Agency: Nuclear Regulatory Commission
Advisory Committee on Reactor Safeguards

Title: Meeting of the Subcommittee on ABP-CE
Standard Plant Designs

DATE: Wednesday, March 9, 1994

NUCLEAR ISLAND STRUCTURES
 PLAN AT LEVEL 1

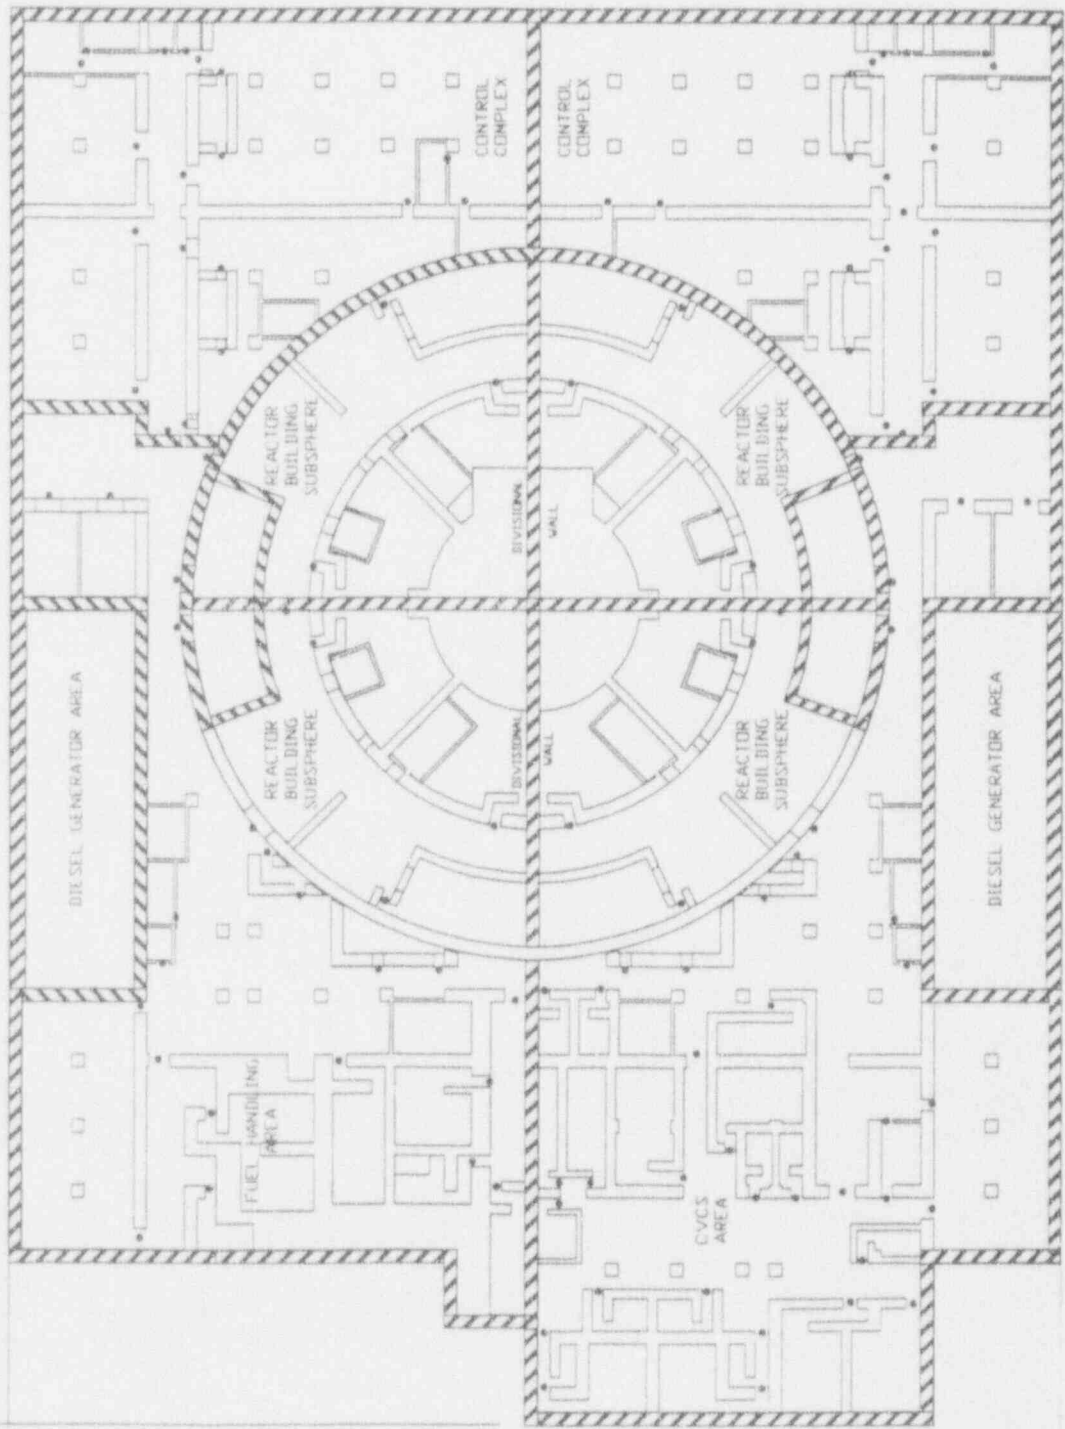
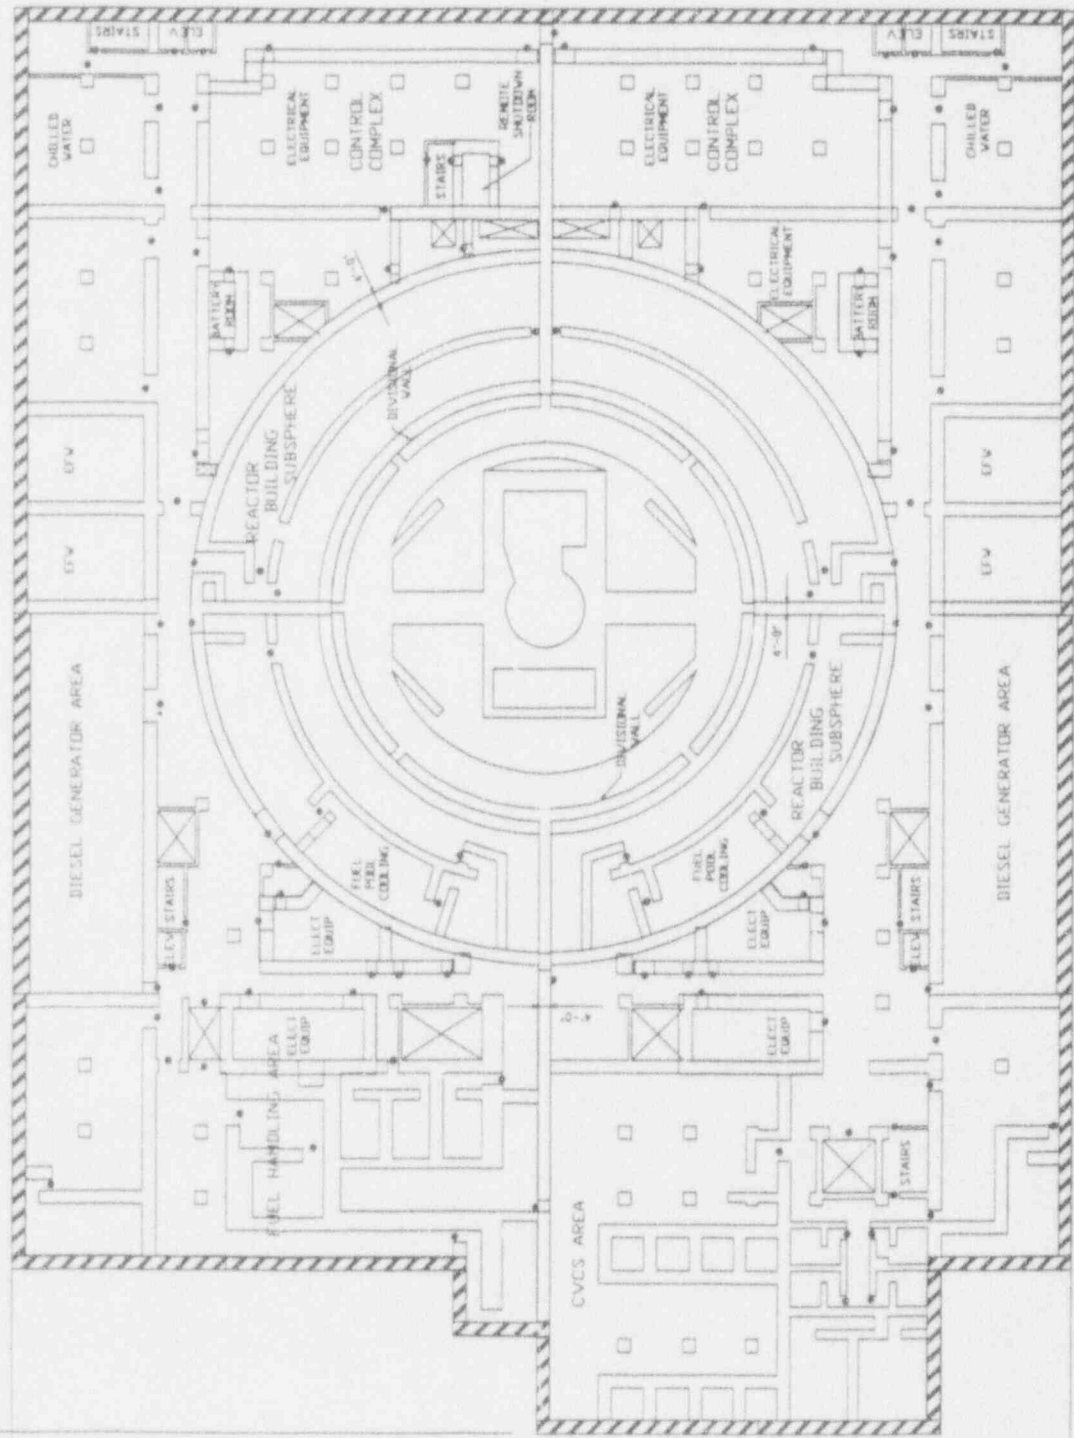
19 MR. CROM: I just wanted to throw up a figure
20 here. I've had the word slides. When we talk about the
21 divisional wall on Elevation 50, we're talking about this
22 wall, all the way across. The quadrant wall is here and, as
23 I said, there are two doors here and here which are flood
24 doors. Each of the motor-driven pump rooms and the turbine-
25 driven pump rooms, and, again, there are doors entering each

3 MR. MICHELSON: I don't recall that one, no.
4 Clarify something for me. What you show here is the
5 vertical divisional wall is under the subsphere.

23 MR. CROM: Look at the plan view. This is the
24 flood barrier I'm talking about right here all the way
25 through around here. This is where your electrical is, your
